CITY OF CALISTOGA

STAFF REPORT

SUBJECT: PRE-APPLICATION CONSULTATION (PA 2008-01) AND
CONCEPTUAL DESIGN REVIEW (CDR 2008-01) FOR
DEVELOPMENT OF THE FORMER HOSPITAL
PROPERTY

FIGURE 1 – CONCEPTUAL DEVELOPMENT PLAN

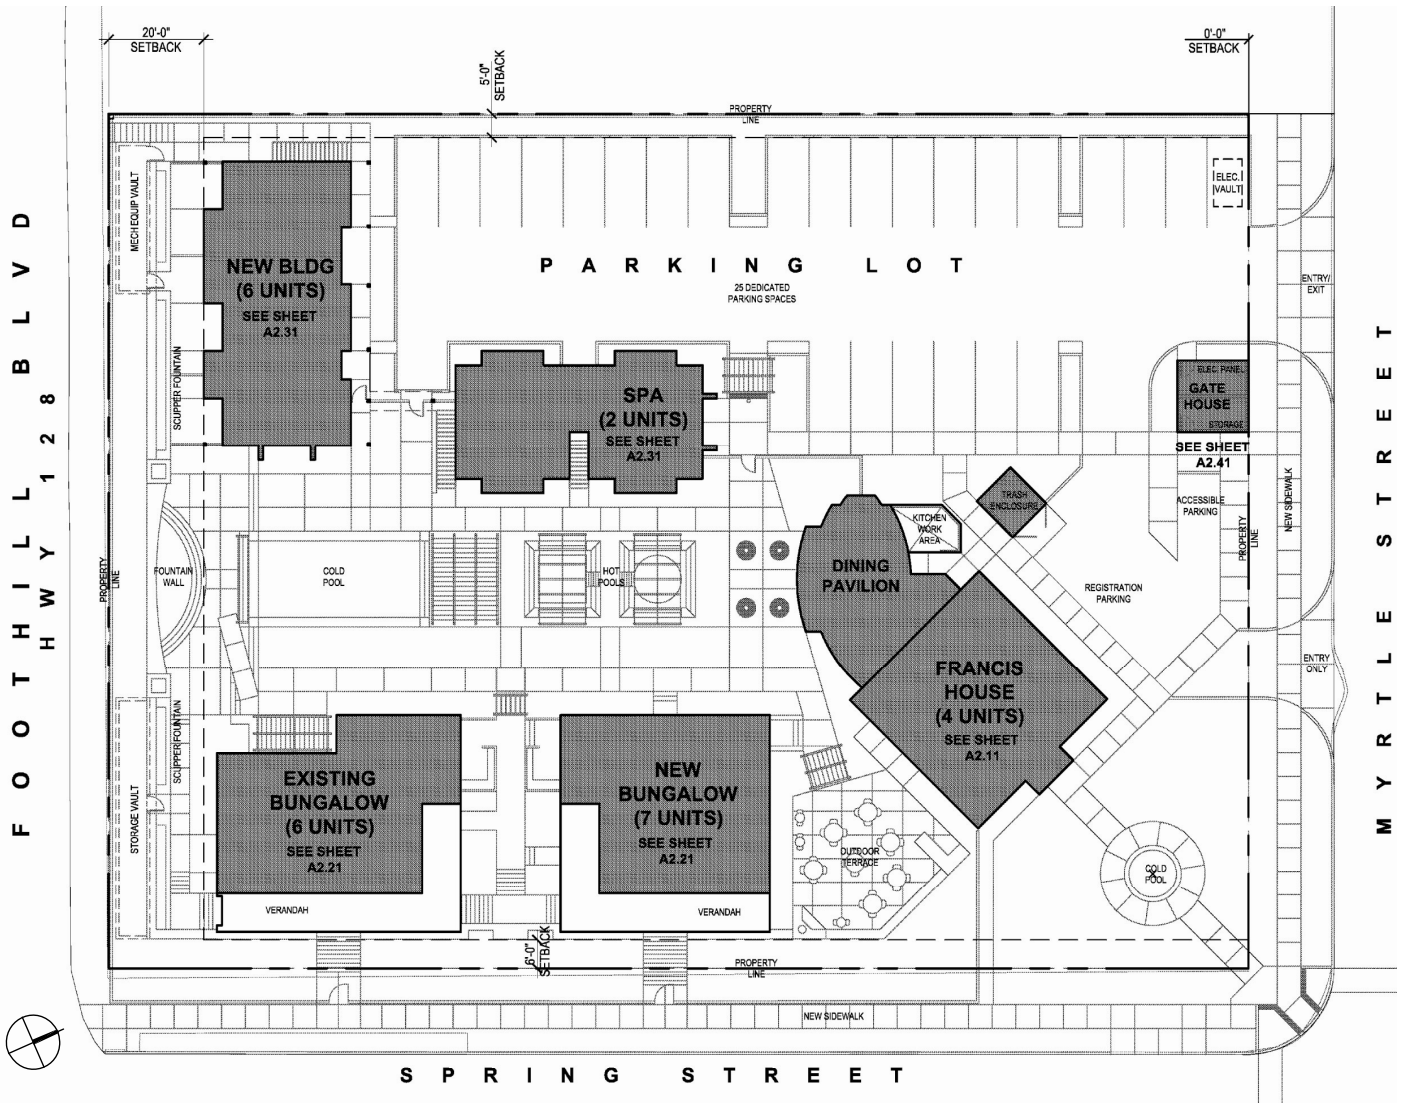
1. On-Site Parking. A total of 32 on-site parking spaces would be required for the project under the City's current parking standards. The owner is proposing a total of 26 on-site spaces (including 1 ADA accessible space) – leaving a deficiency of 6 parking spaces. The submitted narrative does not indicate or address how this deficiency would be addressed or where employees of the inn and spa would park. It is likely that employees will park on the street, impacting the availability of an already limited amount of on-street parking for area residents. This condition could be exacerbated if the spa and event facilities were made available to the public and/or other off-site guests.

2. Building Height. The owner is proposing a height limit of 37 feet. This height limit would recognize the existing height of the Francis House. The proposed new structures range from 22.5 feet in height (Spa and new guest building) to 25.5 feet in height (existing and new Bungalow buildings). The new structures exceed the maximum permissible of the R-3 Zoning District (25 feet) by one-half foot. Should the Planning Commission be concerned about the visual impacts of 25 foot buildings on the surrounding neighborhood, the Commission could request installation of "story poles" for consideration as part of the formal entitlement review process.

3. Street-Side Side Yard Setback. The owner is proposing a street-side side yard setback of 7 feet along the Spring Street frontage of the property, 8 feet less than what would be required under the base zone

342
343 The owner is proposing open metal fencing which will minimize the
344 visual impacts of placing fencing in required setback areas. Staff has
345 some concern about the visibility impacts of 6-foot high fencing at the
346 corner of Spring Street and Foothill Boulevard.

440
441 While it is an appropriate architectural practice to clearly distinguish additions
442 from the historic resource, staff is concerned that the architectural form, shapes
443 and patterns found on the dining pavilion will draw more attention to the disparate
444 architectural styles of the various buildings rather than foster a sense of
445 cohesion.
